From: Ryan Dyck <ryandyck@orrsc.com>
Sent: Tuesday, August 5, 2025 10:21 AM
To: Nolan Card; Jeff Shaw
Cc: ORRSC Subdivision; Max Kelly
Subject: historic landfill
Attachments: aep-guideline-for-setback-reviews-waste-facility (5).pdf

NOTICE OF INCOMPLETE SUBDIVISION APPLICATION

RE: Lot 15, Block 38, Plan 1112938 and Lot 3, Block 38, Plan 7811160 within SW1/4 10-3-25-W4M / Town of Cardston

PROJECT			
Town of Cardston			
East Area Subdivision			
Proposed Site Lot Layout			
TOWN of CARDSTON			
DRAWN BY	APPROVED BY	DATE	SCALE
BLJ		07/14/2025	
JOB NO.	DWG NO.	REV	SHEET
			1 of 1

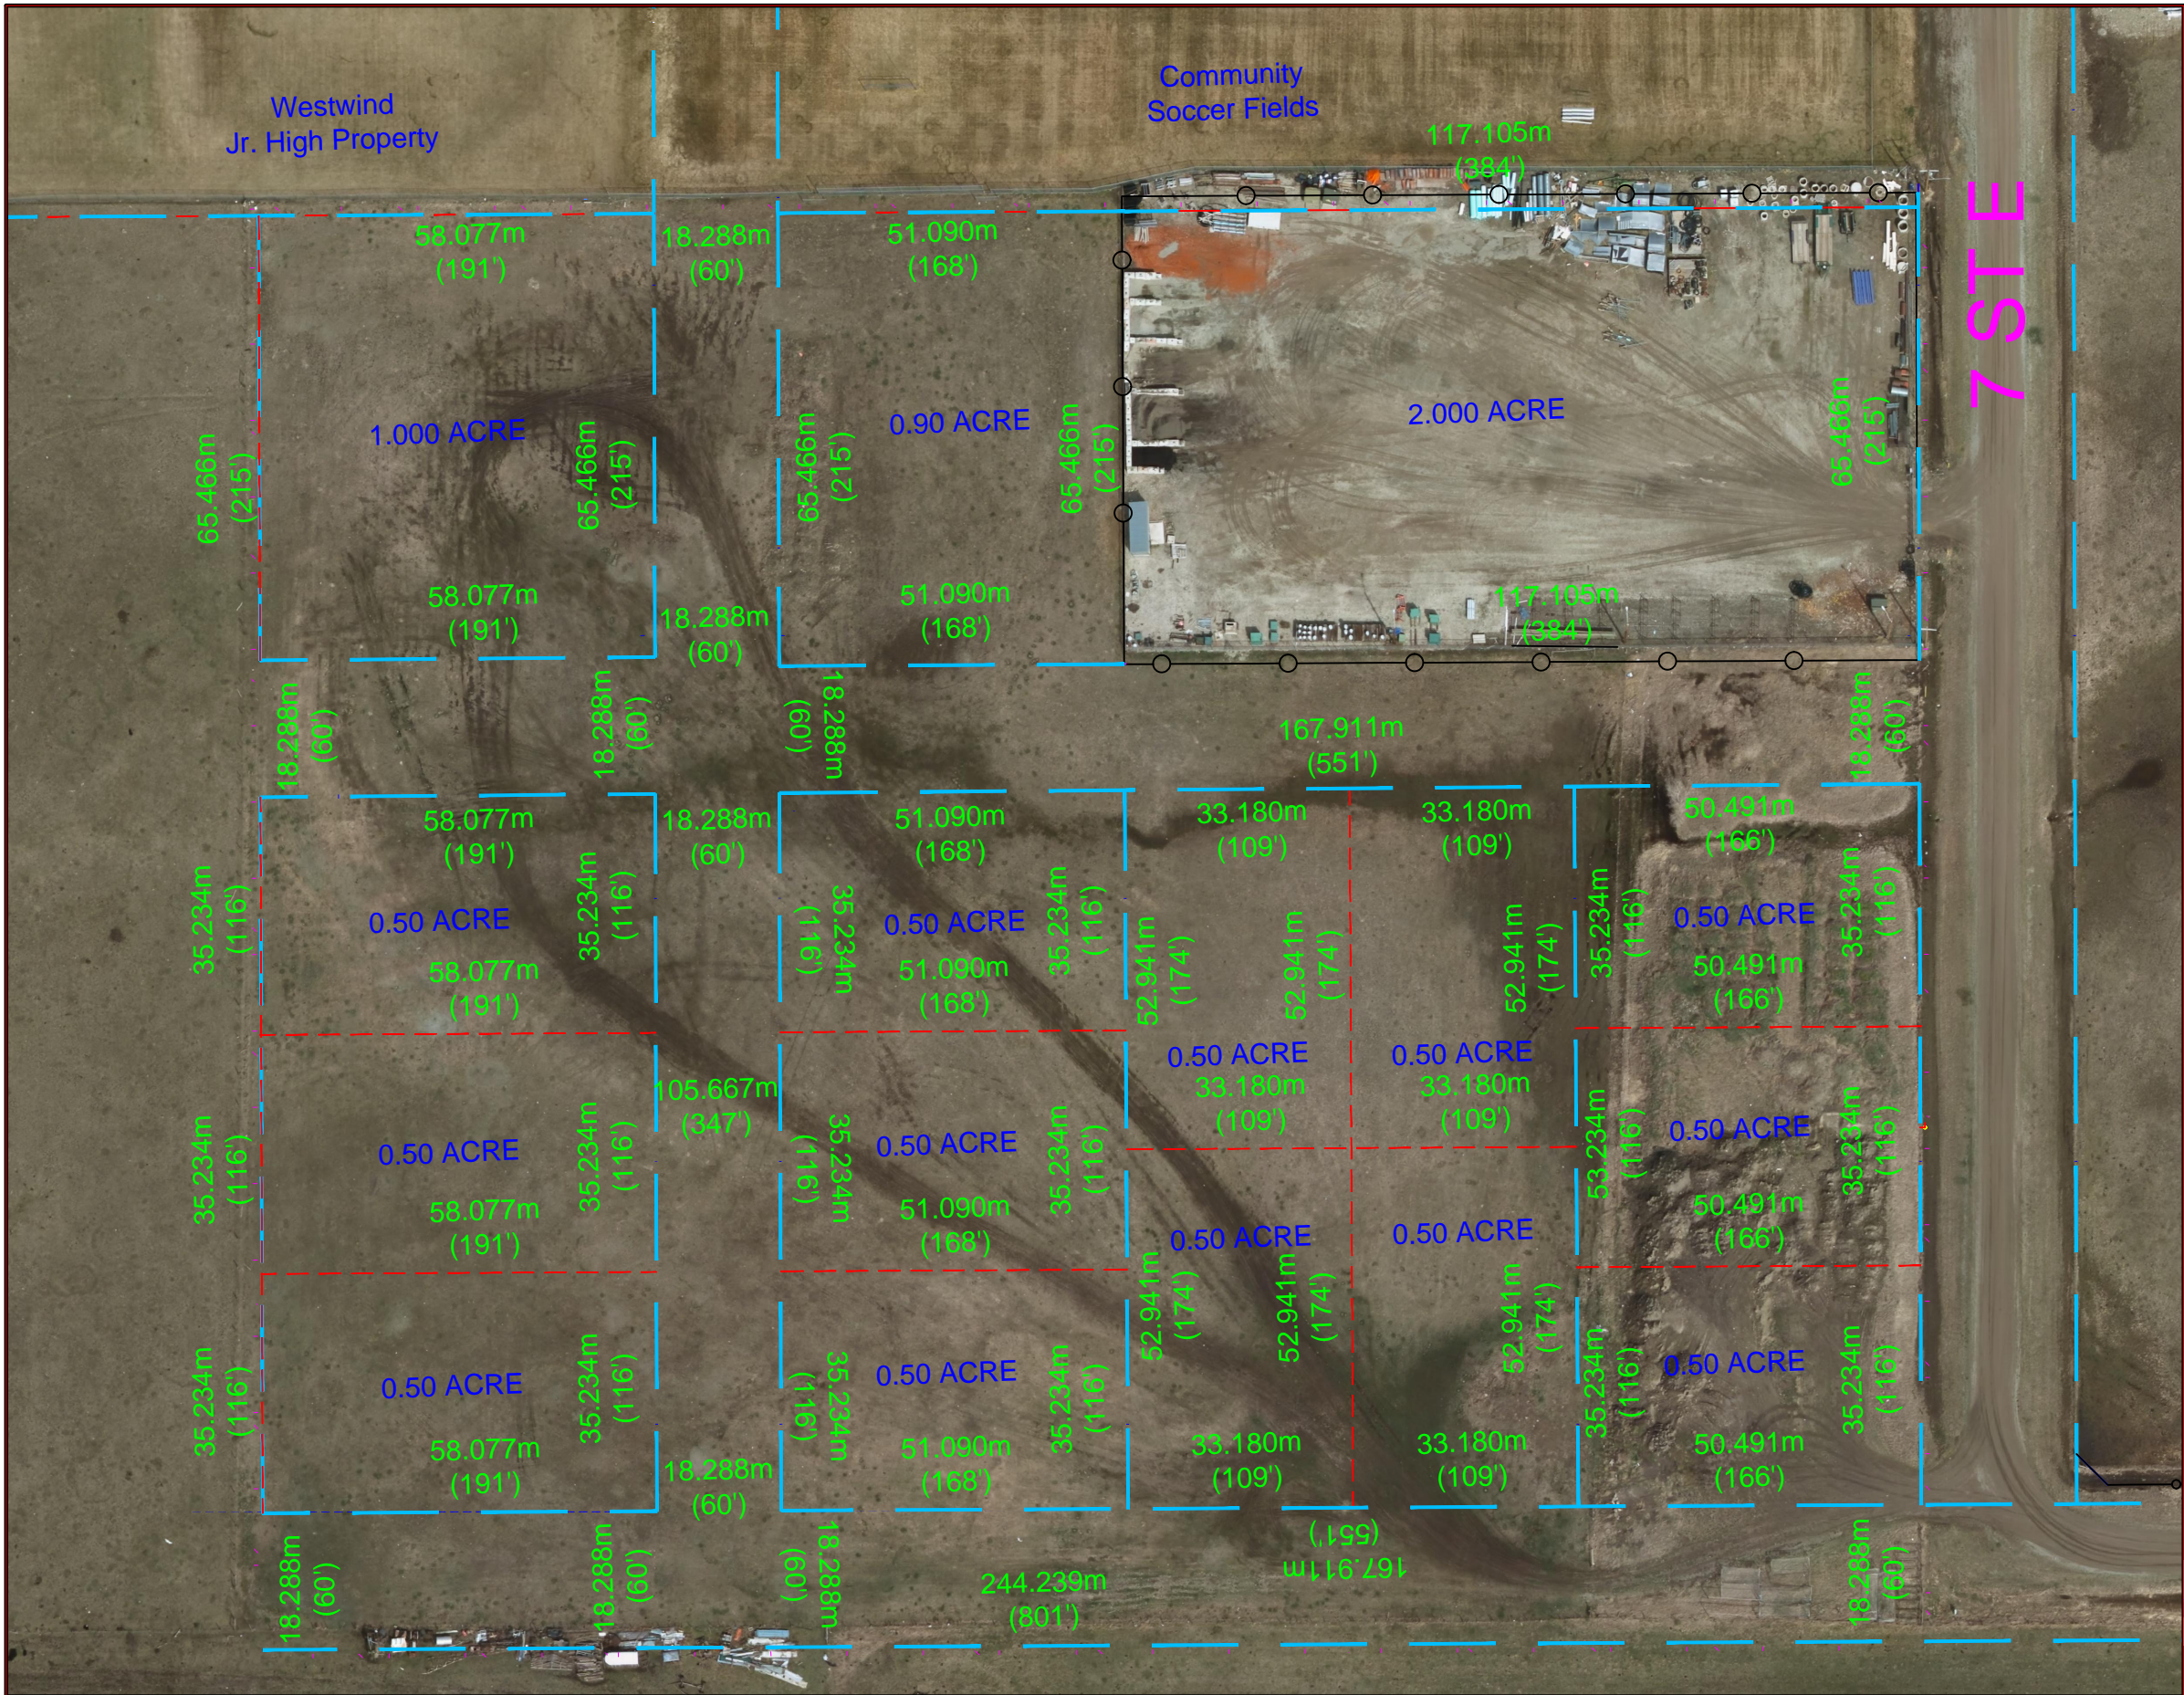
1. Engineering report prepared pursuant to the Guideline for Setback Review document in respect of historical landfill; OR
2. Report prepared to the satisfaction of the Subdivision Authority that confirms the historical landfill has been reclaimed.
